SAFETY RELATED RECALL

Global Recall Action
Number: D145

Subject: Rear View Camera	Publication No.: D145
	Model: Discovery (LR)
	Model Year: 2021 - 2025
	Date of Issue: 30 July 2026

SERVICE INSTRUCTION - D145

3.

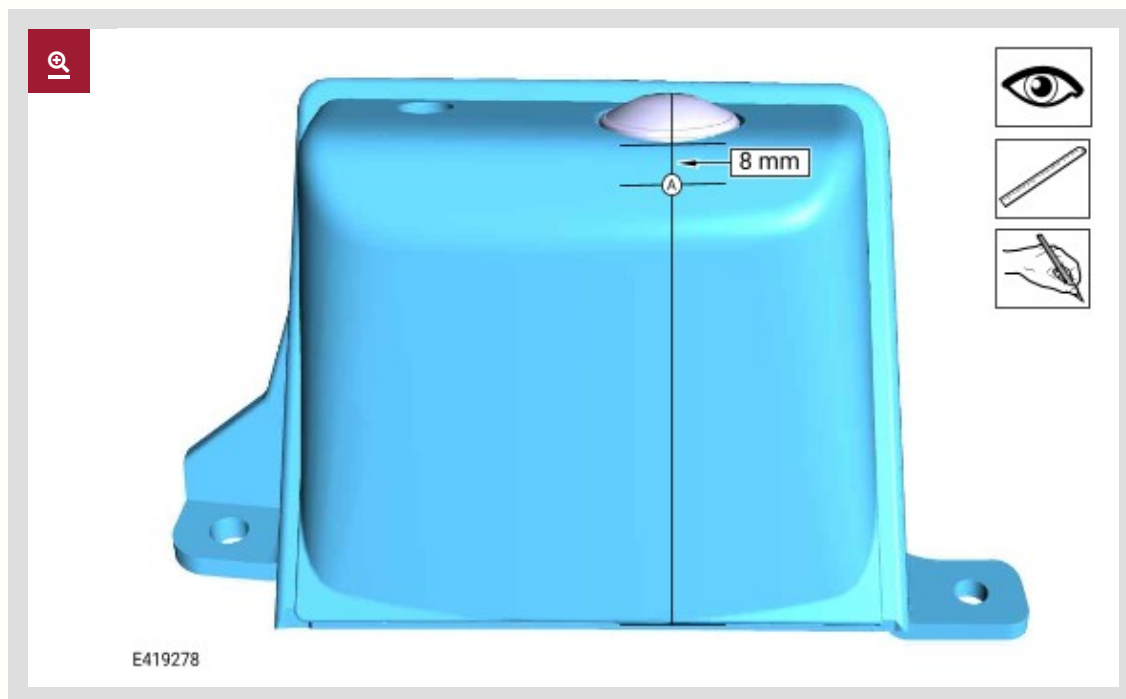
Extra care must be taken when completing this step.

Using the measurement shown, and the centerline of the rear view camera as a guide, use a suitable method to mark point (A) in the illustration.

4.

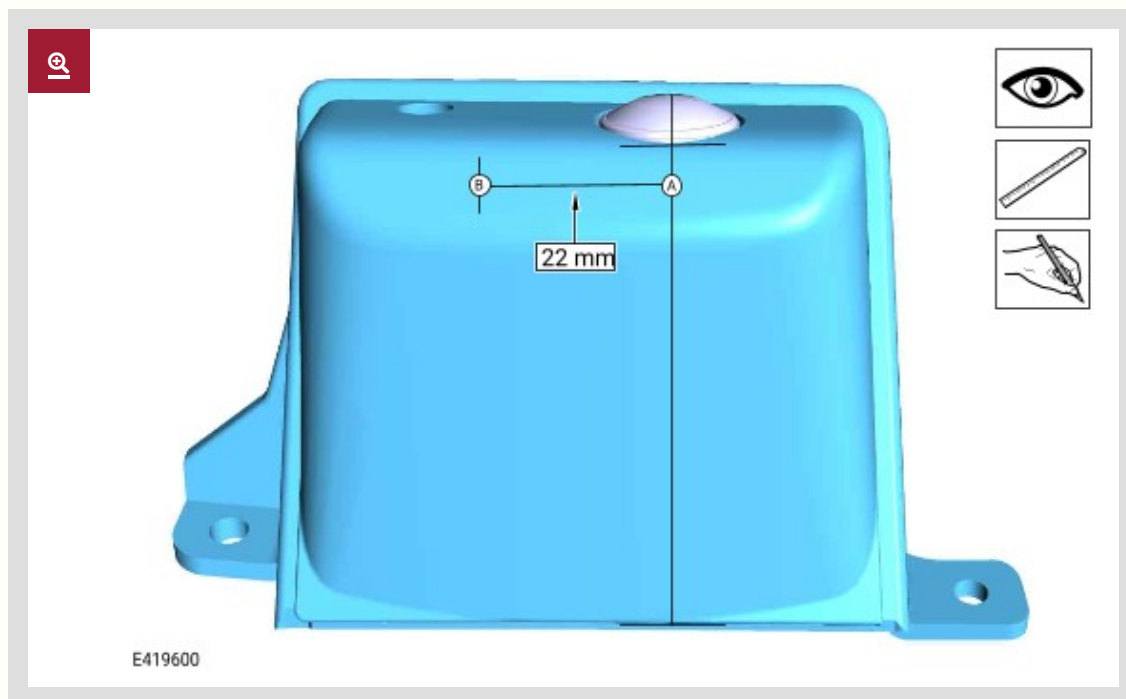
Extra care must be taken when completing this step.

Using the measurement shown, and point (A) as a guide, use a suitable method to mark point (B) in the illustration.

5.

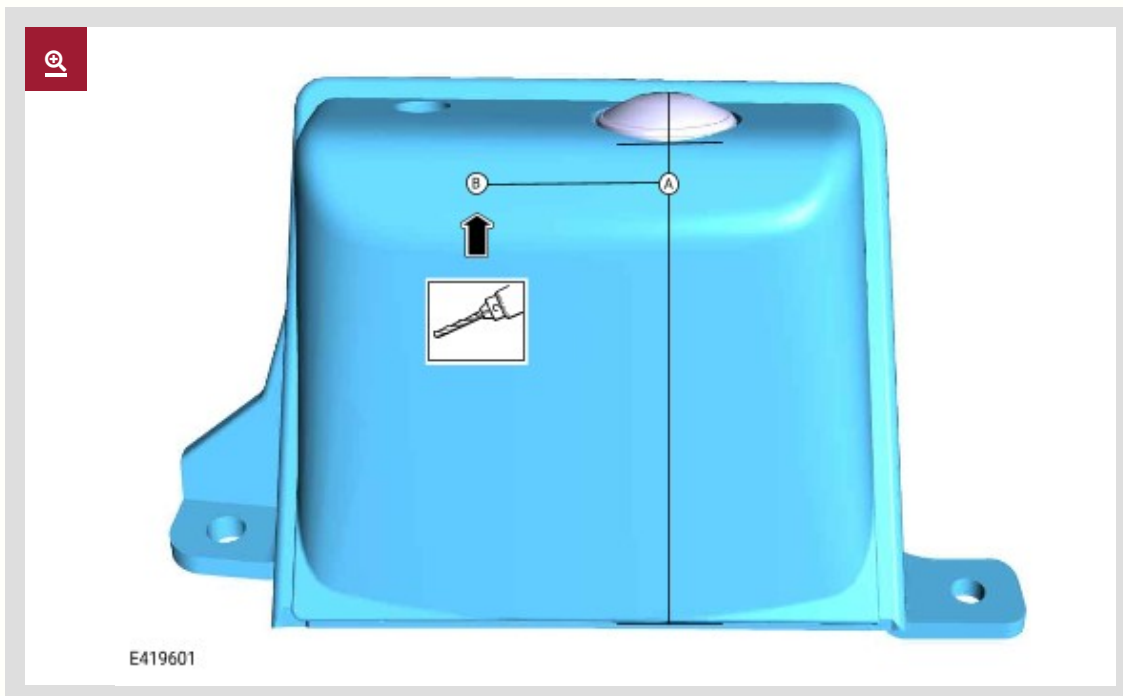
- Use very light pressure and a controlled, slow drilling speed.
- Do not exceed a drilling depth of 10 mm from the surface of the plastic rear view camera housing.
- If required, apply suitable tape to the drill bit, positioned 10 mm from the tip, to act as a depth guide and to prevent drilling too deeply.
- Drill bits **MUST** be new or in a serviceable condition to allow for a clean, accurate hole to be drilled. Using worn or damaged drill bits can result in poor hole quality and potential damage to surrounding components.
- Extra care **MUST** be taken when completing this step.

Use a suitable drill with suitable drill bits to drill a hole through point (B) in the illustration.

1. Use a 2 mm drill bit to drill a 2 mm hole through point (B) in the illustration.
2. Use a 4 mm drill bit to widen the drilled hole to 4 mm.
3. Use a 6 mm drill bit to widen the drilled hole to 6 mm.
4. Use a 7 mm drill bit to widen the drilled hole to 7 mm.
